Service Bulletin No: 27-009**Ref No: 221****ATA Chapter: 27**

**FLIGHT CONTROLS - YAW CONTROL
RUDDER TRIM TAB, SHORT CONTROL RODS - THREADED BOLT REPLACEMENT****1. Planning information****A. Effectivity**

PC-24 aircraft MSN 101 - up with 300 FH or more, with titanium threaded bolts (P/N 527.20.24.489) installed in the rudder trim tab short control rods.

Rudder trim actuator control rods - Inspection
Figure 1 (Sheet 1 of 2)

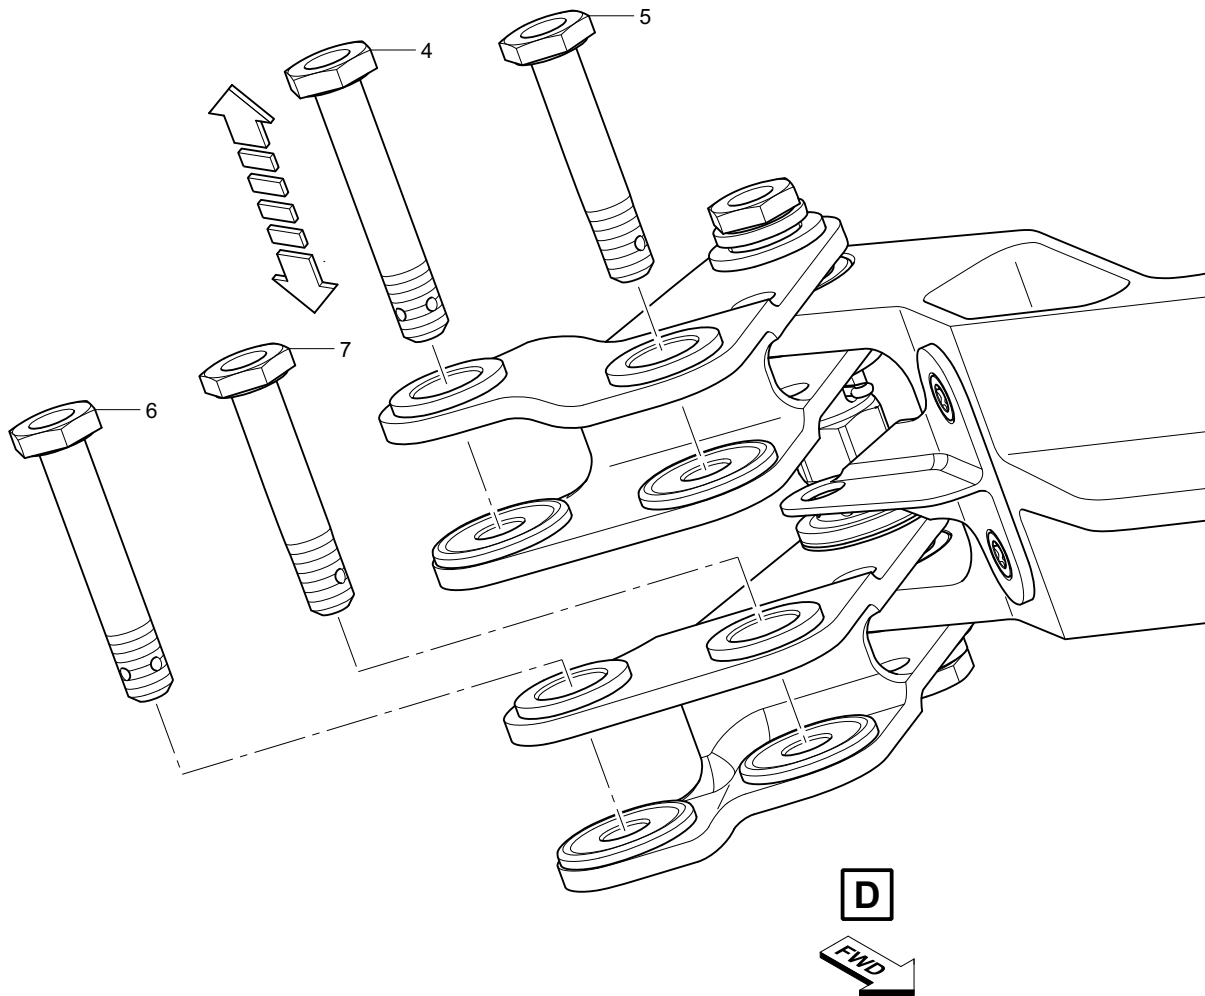
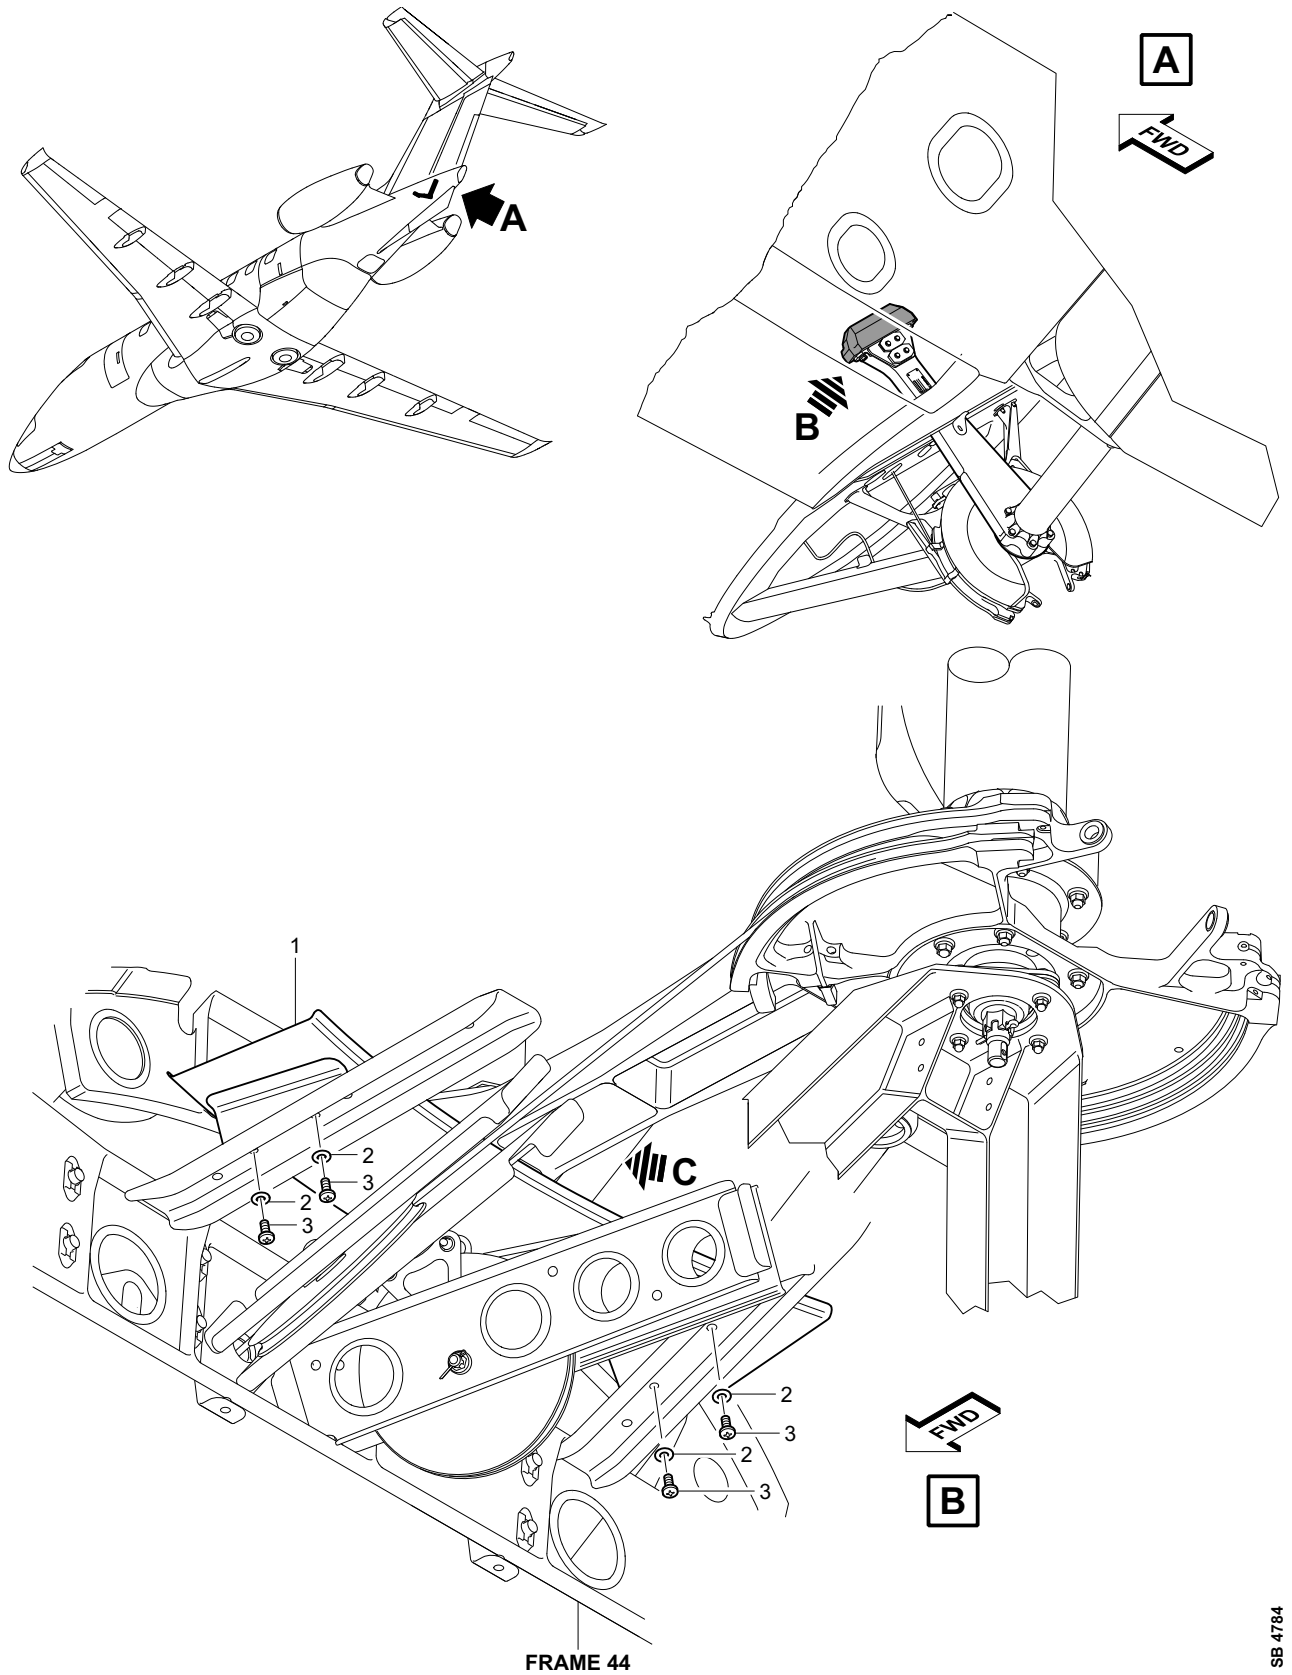
- (1) Do the rudder trim mechanism - visual examination procedure. Refer to AMM PC24-A-E27-20-0005-00A-310A-A.
- (2) When you do the above referenced AMM procedure, make sure that you record the results of the rudder trim tab freeplay check on the Pilatus feedback sheet.
- (3) Do the rudder trim actuator remove procedure. Refer to AMM PC24-A-E27-20-0006-00A-520A-A and Figure 1.

NOTE: When you do the above referenced AMM procedure, make sure that the two rudder-trim-tab short control-rods (1) are removed (and kept) from the rudder trim actuator.

- (a) When you do the above referenced AMM procedure, make a record on the Pilatus feedback sheet if the upper aft bellcrank bolt (4) could easily be removed by hand.

- (b) When you do the above referenced AMM procedure, remove the lower aft bellcrank bolt (6) from the lower bellcrank.
- (c) Do a visual inspection of the four bellcrank bolts (4), (5), (6), and (7) for damage and fretting.

- (4) Remove the two threaded bolts (3) and the two lock washers (2) from the two rudder-trim-tab short control-rods (1).
- (5) Discard the two lock washers (2).

- (10) Install the two new threaded bolts (3) and the two new lock washers (P/N 938.83.12.001) (2) on the two rudder-trim-tab short control-rods (1) (that you kept).

- (11) Torque the two threaded bolts (3) to between 66 and 75 lbf in (7.5 and 8.5 Nm) plus the run-down torque.
- (12) Safety the threaded bolts (3) with the two lock washers (2).

Inspection of the rudder mass balance arm
Figure 2 (Sheet 1 of 2)

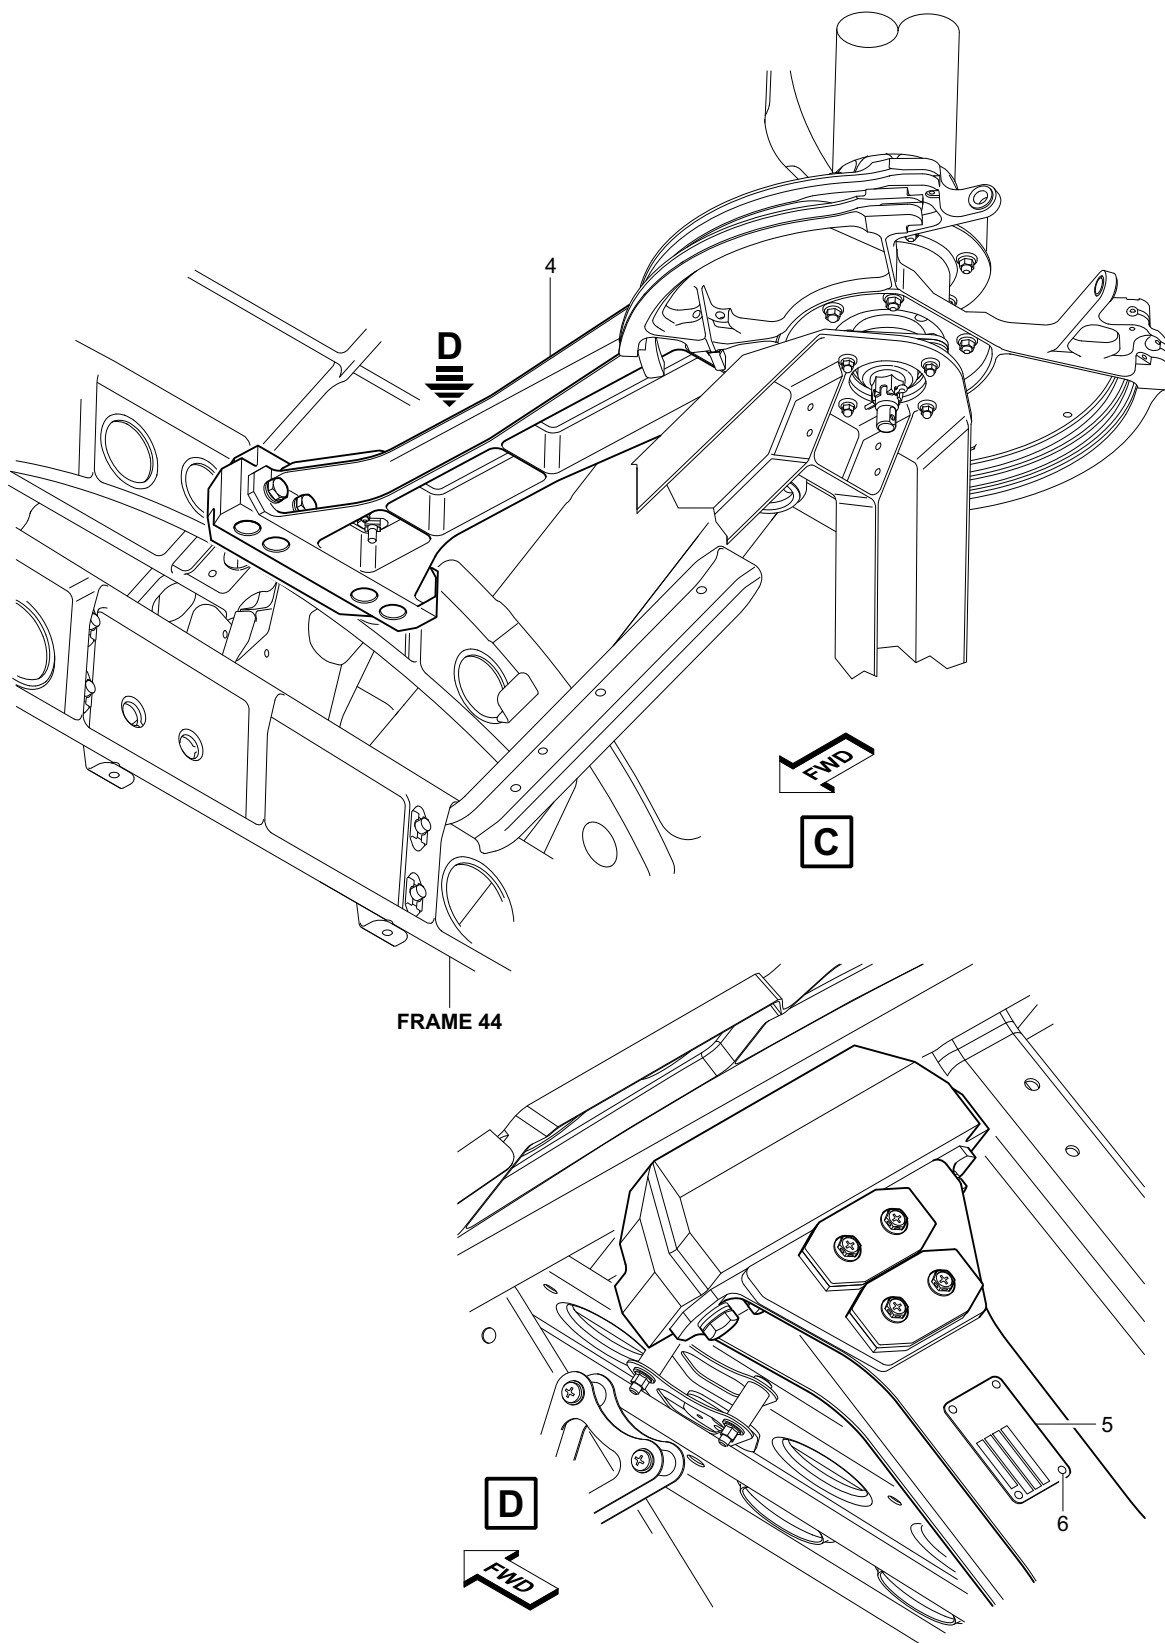
(1) Do a visual inspection of the rudder mass balance arm as follows. Refer to Figure 2:

(b) Remove the autopilot cable cover (1) as follows:

(c) Use wipes, pre-saturated solvent (Material No. P01-033) to clean the rudder mass balance arm (4).

(d) Use a mirror and a torch (flashlight) as necessary to do a visual inspection of the rudder mass balance arm (4), the identification placard (5), and the four rivets (6) for:

- Correct attachment
- Damage
- Cracks
- Deformation
- Surface finish
- Corrosion. Refer to AMM PC24-A-E20-40-0000-00A-040A-A.

(e) If damage is found on the rudder mass balance arm, contact Pilatus Aircraft Ltd before the next flight.
